**SAN BERNARDINO COUNTY
DEPARTMENT OF PUBLIC WORKS - SPECIAL DISTRICTS**

**ADDENDUM NO. 1
TO THE BIDDING REQUIREMENTS &
CONTRACT DOCUMENTS FOR
CSA 70 – SCREW PRESS SLUDGE DEWATERING PROJECT**

May 14, 2021

**RAS DIRECT CONNECT AT SPLITTER BOX
DETAIL**

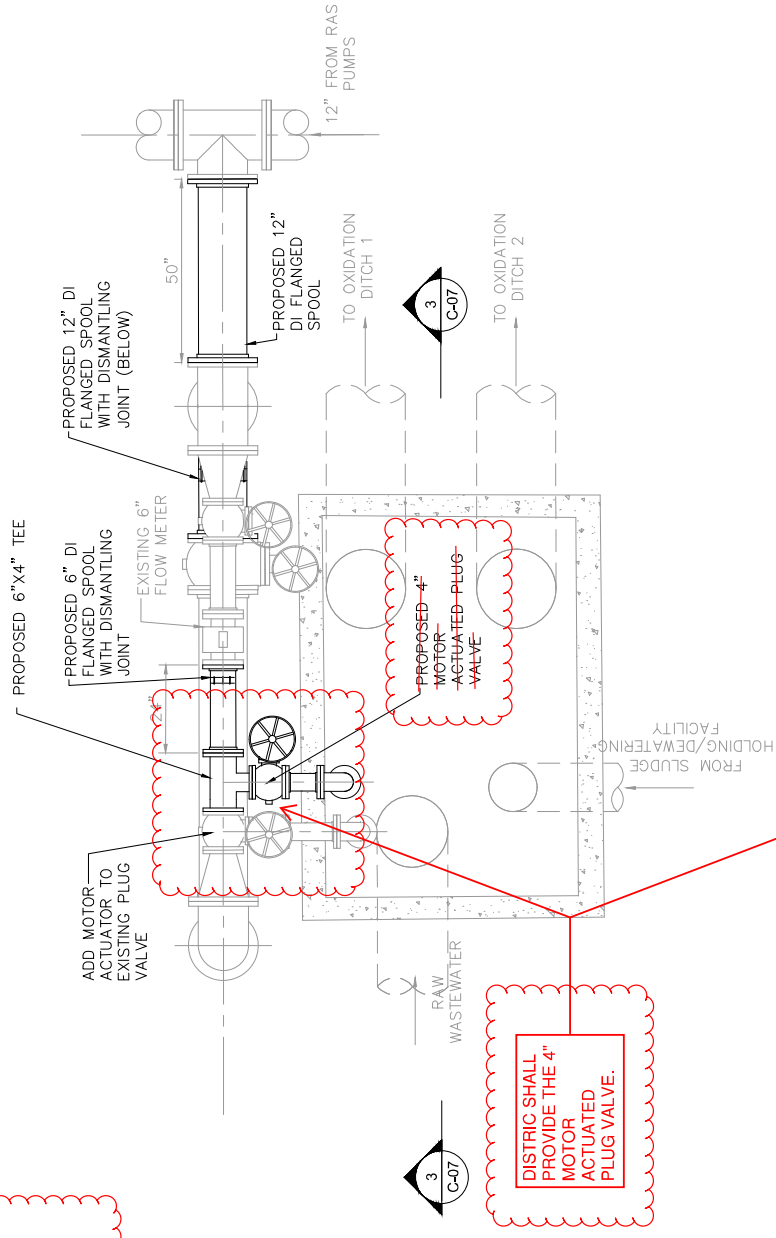
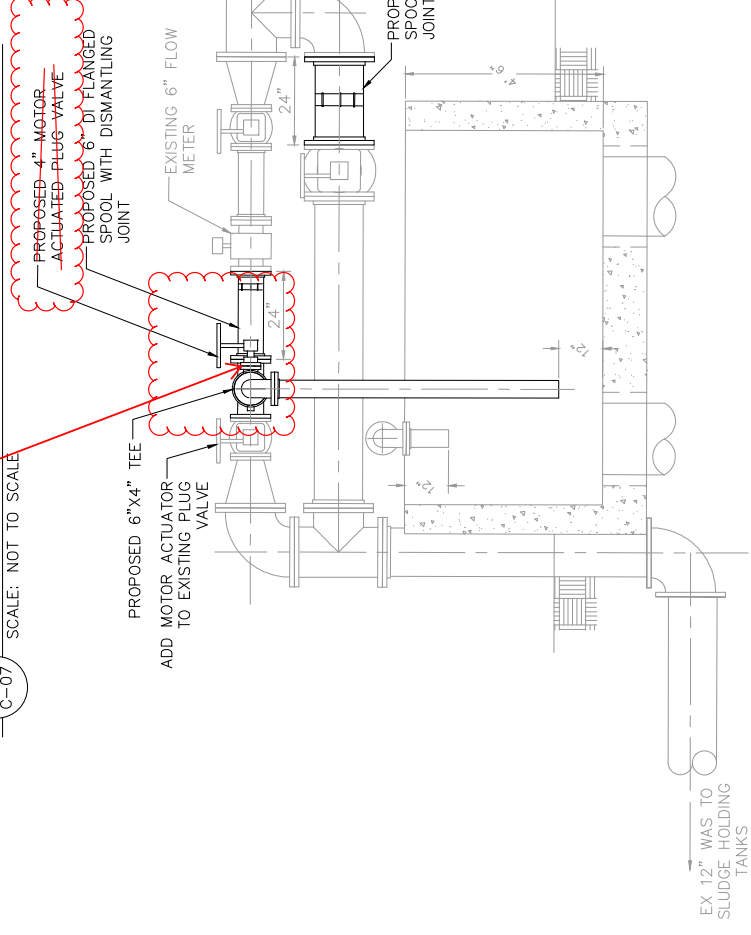
2. ITEM NO. 2: MODIFY DRAWING SHEET C-07

District shall provide the 4” Motor Activated Plug Valve. See attached Drawing Sheet C-07.

DISTRICT SHALL PROVIDE THE 4" MOTOR ACTUATED PLUG VALVE.
